Drawing Change Notice

CHANGE DOCUMENT NO.
24590-PTF-VDCN-MS-11-00007

JOB NO.	TITLE FOR CHANGE NOTICE
24590	PTF-FRP-VSL-00002D REDESIGN

JUSTIFICATION FOR CHANGE	CAUSE CODE
Based on the re-analysis of FRP-VSL-00002A/B/C/D, per calculation 24590-PTF-MVC-FRP-00003, for revised seismic conditions and design evolution, a redesign of the vessel is required.	01-23

ON REFERENCE DRAWING 24590-QL-SRA-MTF5-00001-29-06

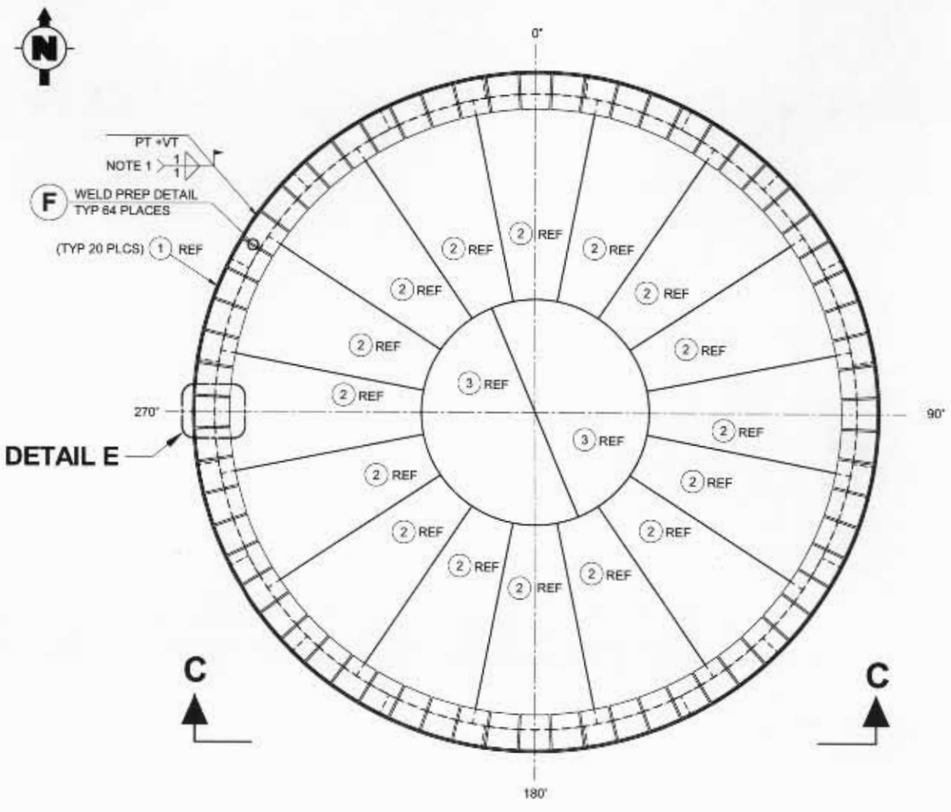
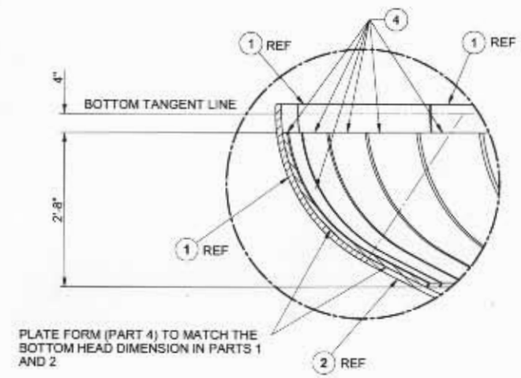
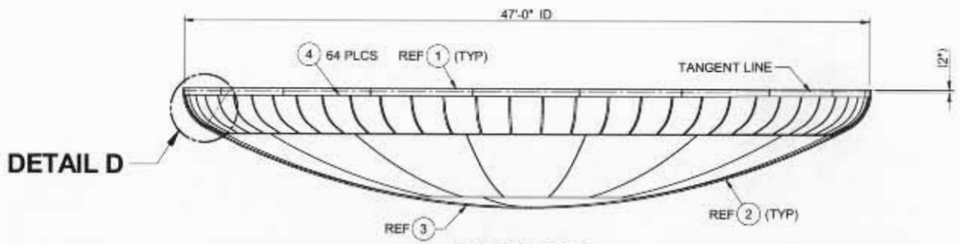
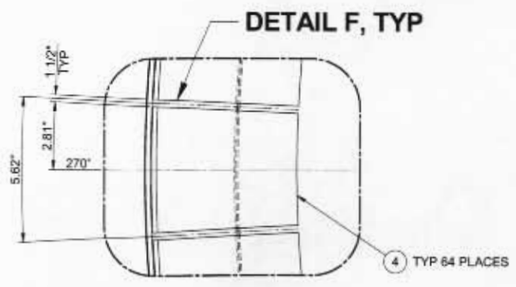
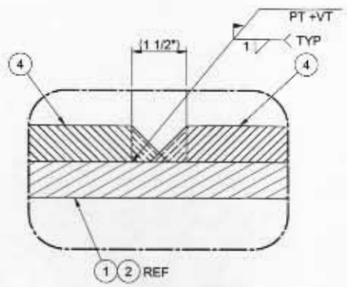
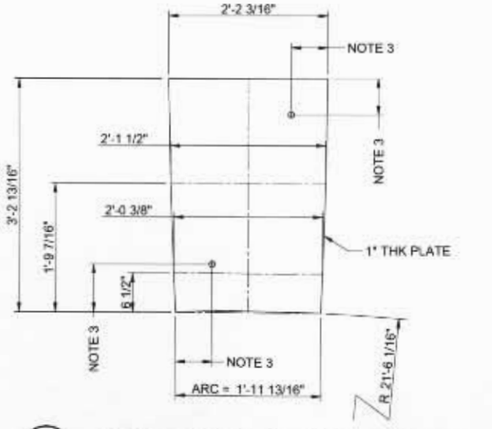
b) Plan View: Add Knuckle Stiffener plates shown on Attachment 1, page 12 of this VDCN.

c) View C-C: Add Knuckle Stiffener plates shown on Attachment 1, page 12 of this VDCN.

Add Knuckle Stiffener Plate, Item 4 shown on Attachment 1, page 12 of this VDCN.

Add Details D, E, and F shown on Attachment 1, page 12 of this VDCN.

1. TYPICAL, 1" WELD SIZE MAY BE REDUCED WHEN BRIDGING WELDS DEPICTED IN DETAIL F.
2. CONTOUR TO MATCH VESSEL BOTTOM HEAD, GAP BETWEEN STIFFENER PLATE AND VESSEL BOTTOM HEAD AS MEASURED THROUGH FILL AND VENT HOLES, SHALL NOT EXCEED 1/4".
   NOTE: WIDTH OF PLATES MAY BE ADJUSTED TO SHIFT WELD LOCATIONS OR TO CREAT LARGER PLATES TO REDUCE TOTAL NUMBER OF STIFFENERS PLATES. DETAIL F SEAMS SHALL NOT BE LOCATED CLOSER THAN 3" FROM SEAMS IN BOTTOM THAT RUN PARALLEL TO DETAIL F SEAMS.
3. LOCATE 1 FILL AND 1 VENT HOLE, APPROX. AS SHOWN, NOMINALLY 10" FROM CORNER OF STIFFENER PLATES PLATE (PART #5-4). FILL GAPS BEHIND STIFFENER PLATES (PART #5-4) WITH GROUT UNTIL GROUT BLEEDS FROM VENT HOLES. AFTER GROUT SETS, DRILL OUT GROUT FROM FILL AND VENT HOLES MIN. 3/4" DEEP. PLUG WELD HOLES CLOSED MIN. OF 1/2" DEEP. HOLES MAY BE SIZED/TAPPED AS NEEDED UP TO 1" Ø, TO FACILITATE INSTALLATION OF GROUT.

ON REFERENCE DRAWING 24590-QL-SRA-MTF5-00001-29-17

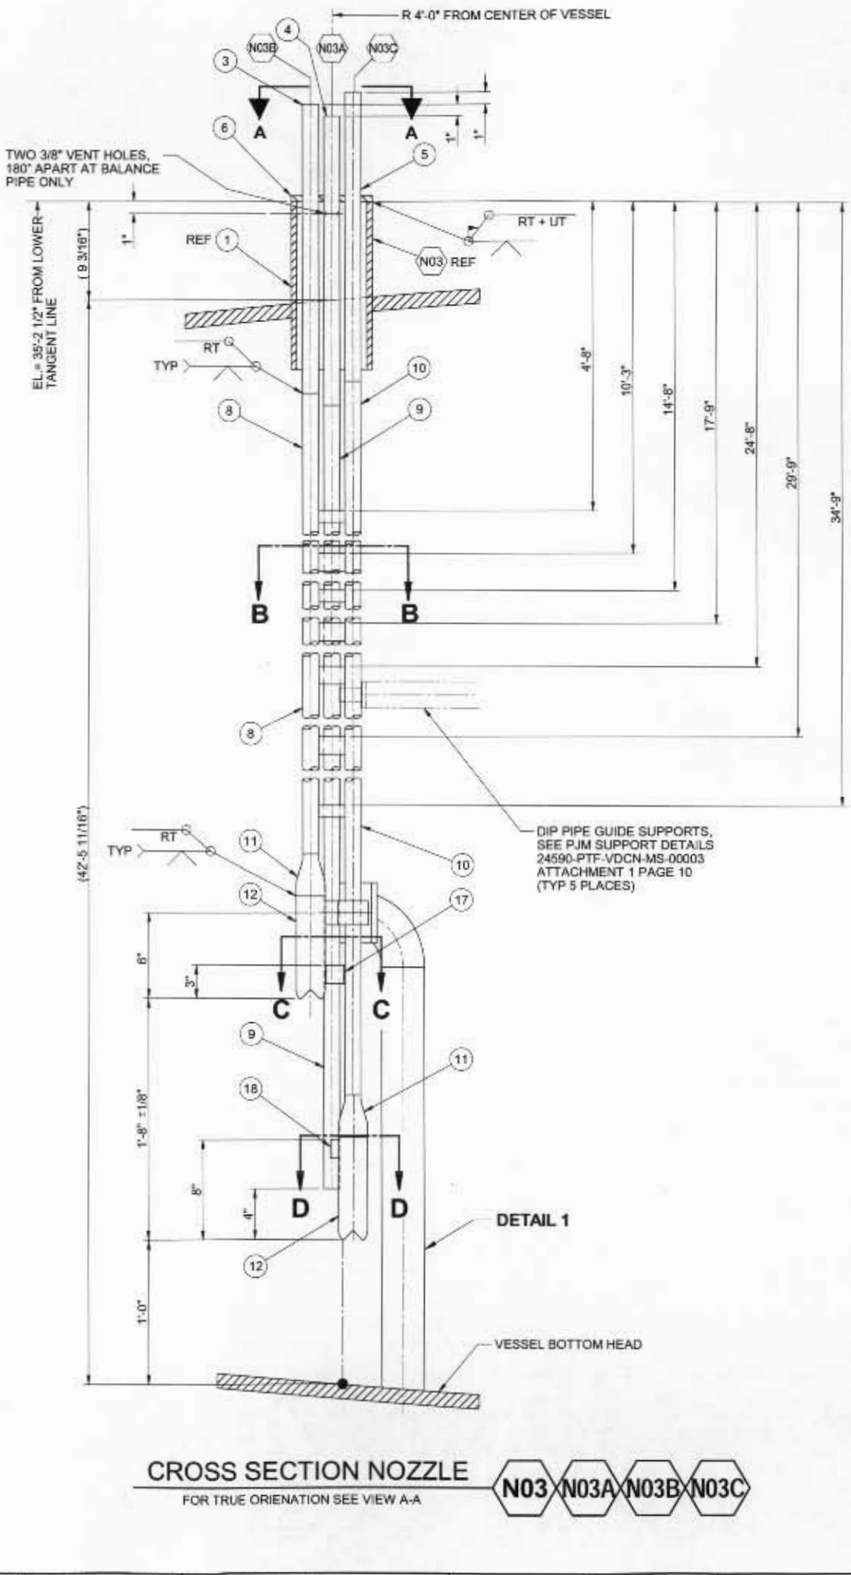
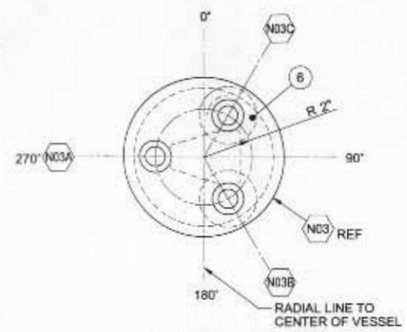
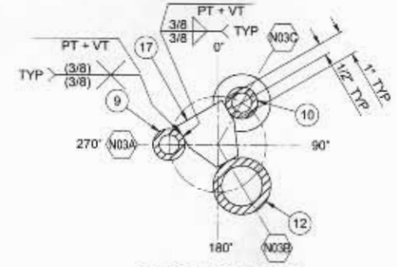
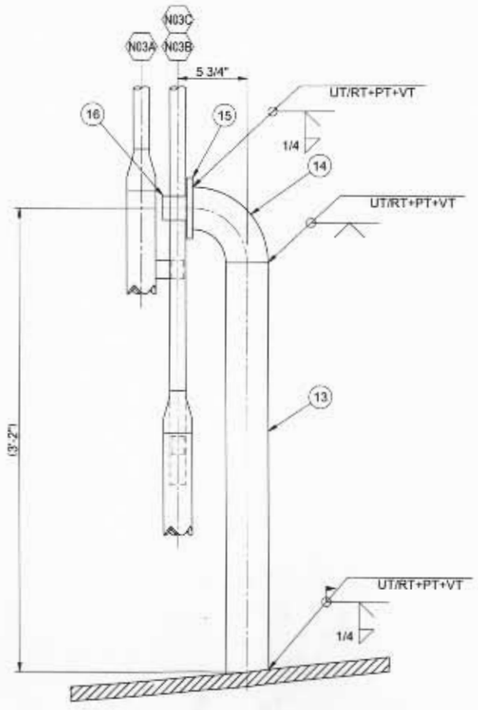
g) Nozzle N3 Assembly Drawing: Add View, Details, and Sections and Item shown on Attachment1, page 13 of this VDCN.

View A-A

Detail 1

Sections B-B, C-C, and D-D

Item 16 Pipe Guide Strap

1. PIPE GUIDE STRAPS ARE WELDED AFTER CORRECTLY POSITIONING THE PIPE GUIDE STRAP SUPPORTS.PIPE GUIDE STRAP SHALL MAINTAIN 1/16" DIAMETRICAL CLEARANCE WITH PIPE.
2. TOLERANCE ON STRAP ELEVATIONS (PART 12-7) IS ±2".

ON REFERENCE DRAWING 24590-QL-SRA-MTF5-00001-29-21

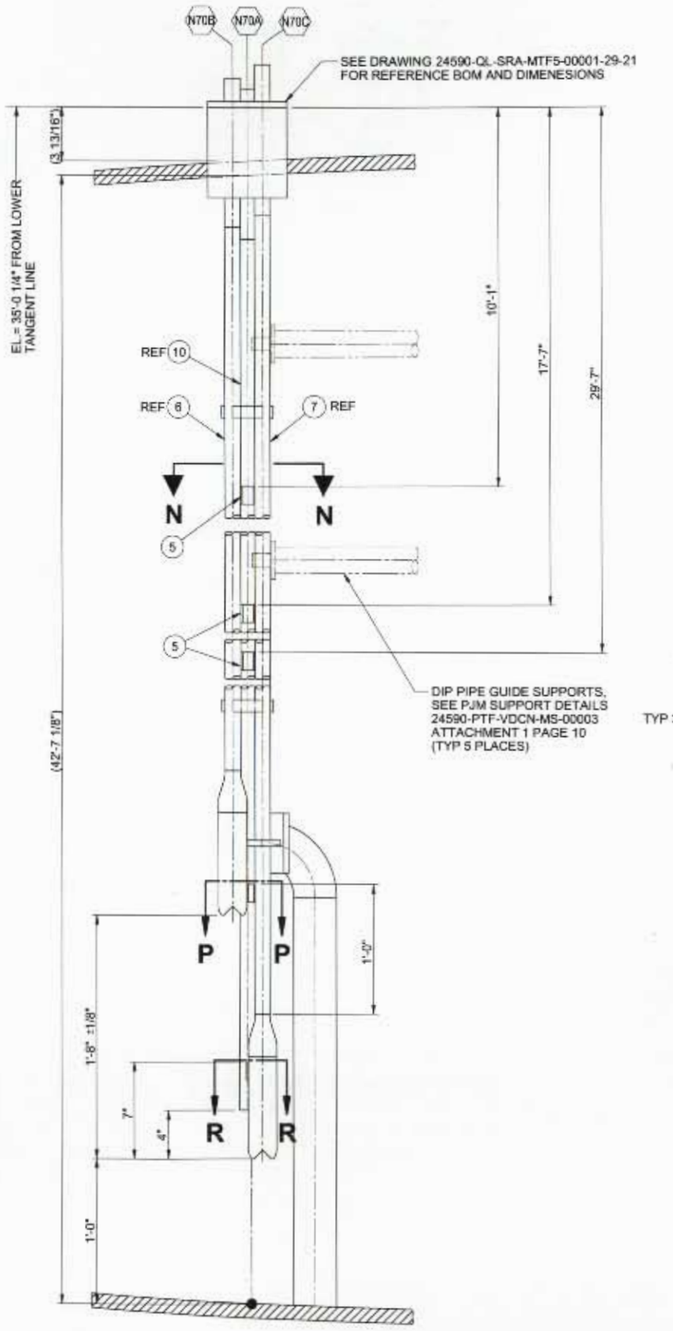
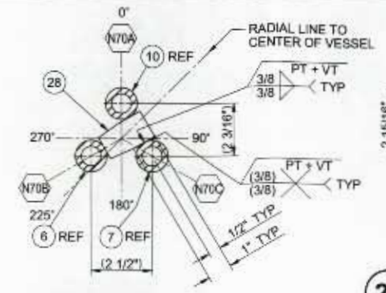
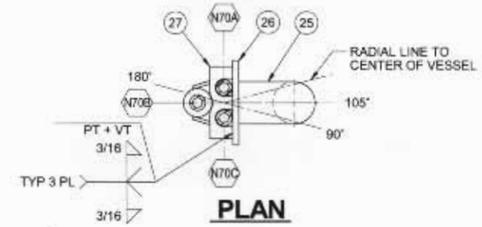
i) Nozzle N70 Assembly Drawing: Add Detail, and Section and Item shown on Attachment1, page 14 of this VDCN.

Detail 1

Section N-N

Item 27 Pipe Guide Plate

c) Section J: Replace Item 5 (Plate 1/2") with Item 29 (Block Plate) as shown on Attachment 1, page 14, Section P-P of this VDCN.

d) Section M: Replace Item 5 (Plate 1/2") with Item 30 (Block Plate) as shown on Attachment 1, page 14, Section R-R of this VDCN.

1. PIPE GUIDE STRAPS AND PLATE ARE WELDED AFTER CORRECTLY POSITIONING THE PIPE GUIDE STRAP SUPPORTS.PIPE GUIDE STRAP AND PLATE SHALL MAINTAIN 1/16" DIAMETRICAL CLEARANCE WITH PIPE.
2. THE FABRICATOR MAY LEAVE UP TO 1" OF THE PREVIOUS STEELWORK IN PLACE (I.E. CUT STEELWORK UP TO 1" AWAY FROM UNTOUCHED COMPONENTS) TO AVOID CUTTING/GRINDING INTO UNTOUCHED COMPONENTS (UNLESS OTHERWISE SPECIFICALLY INDICATED IN THIS DRAWING SET) WHERE THIS DRAWING SET INDICATES THAT SUPPORTS, FLANGES, BRACKETS, COMPONENTS, ETC. HAVE BEEN REMOVED BETWEEN THE CURRENT REVISION AND THE PREVIOUS REVISION.
3. TOLERANCE ON STRAP ELEVATION IS ±2".

ON REFERENCE DRAWING 24590-QL-SRA-MTF5-00001-29-23

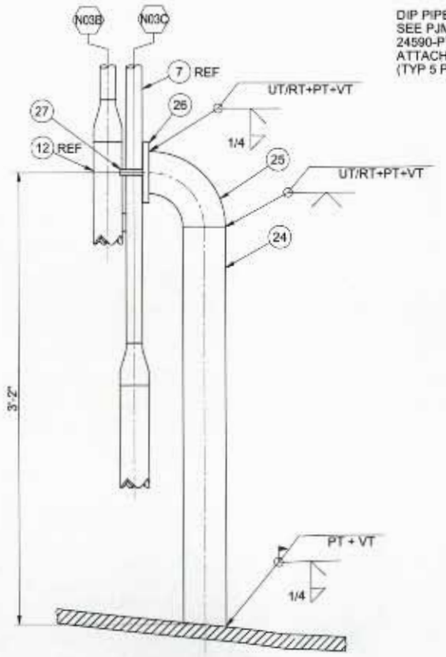
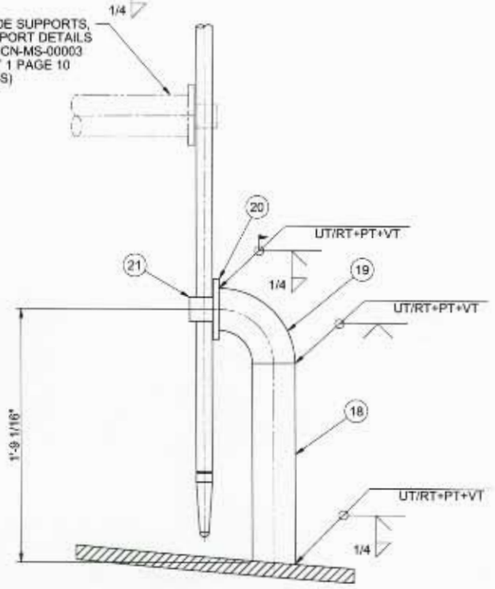
c) Elevation view: Add the following Items shown on Attachment 1, page 14 of this VDCN.

Items 18, 19, 20 and 21

f) N18 3/4" DIA Temperature Drawing: Add the following Item:

Item 21 Pipe Guide Strap

ON REFERENCE DRAWING 24590-QL-SRA-MTF5-00001-29-29

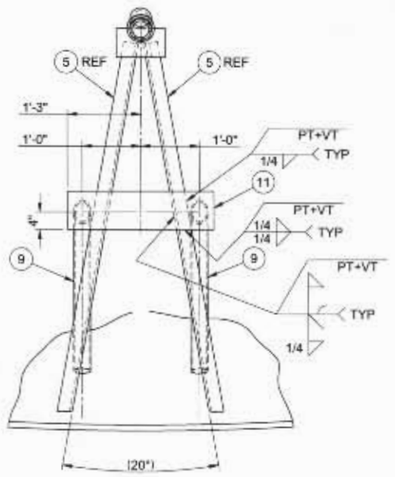
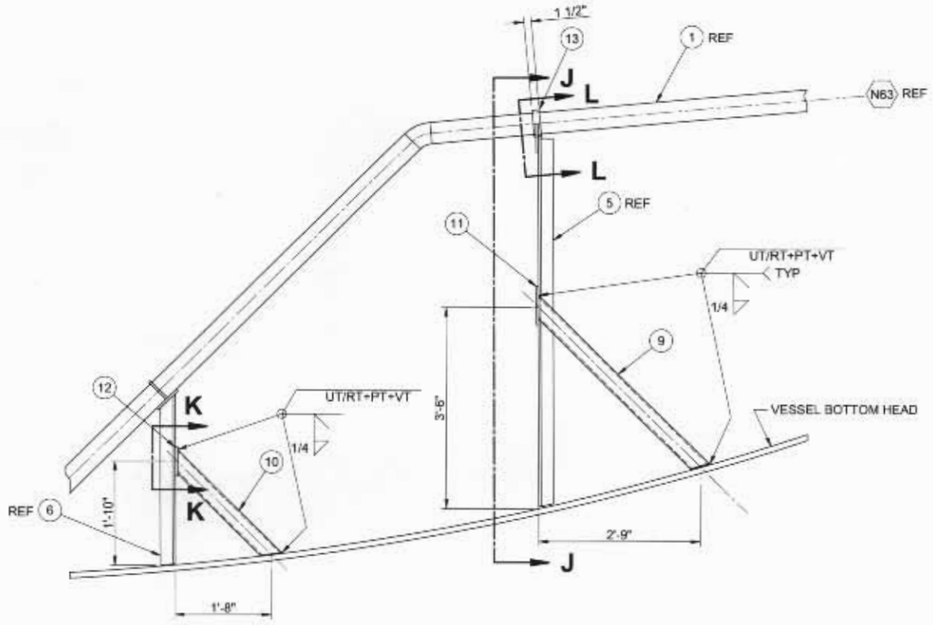
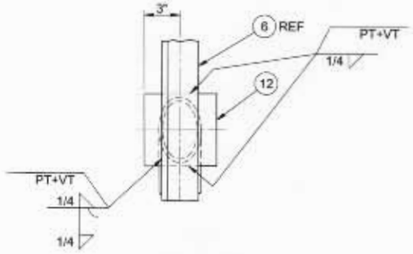
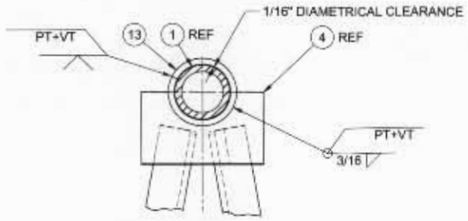
a) Bill of Materials block: Add the following line Items shown on Attachment 1, page 15 of this VDCN.

b) Section A: Add the following Items shown on Attachment 1, page 15 of this VDCN.

c) Section A and Nozzle N64 Plan View of Nozzle: Update depiction on PJM support to show new PJM lateral supports and PJM eccentric nozzle as shown on Attachment 1, page 7 of 24590-PTF-VDCN-MS-11-00003 document.

c) N63 4" Dia Details Drawing: Add the following Sections, View and Items shown on Attachment 1, page 15 of this VDCN.

Sections A-A, L-L and J-J

View K-K

24590-QL-SRA-MTF5-00001-29-32
REV 00 B

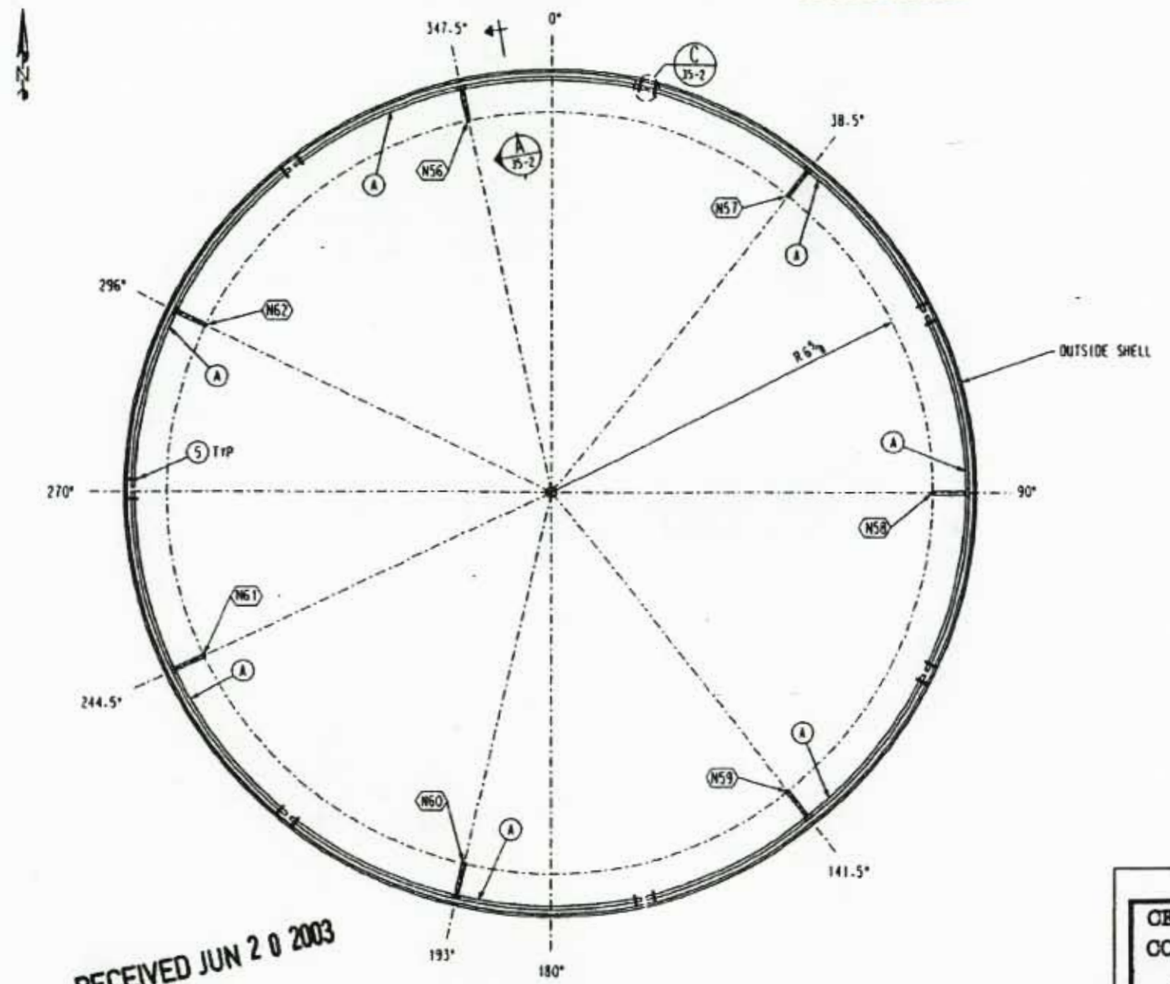
12. Affected Document: 24590-QL-SRA-MTF5-00001-29-32 (see Attachment 1, page 16 of this VDCN).

a) Bill of Materials block: Revise the following line Items:

Line Item 35-1 Description block: Sch 40S to Sch 160S.

Line Item 35-2 Description block: Sch 40S to Sch 160S.

Line Item 35-3 Description block: Sch 40S to Sch 160S

REVISE BY RPP-WTP ON HOLD 160S
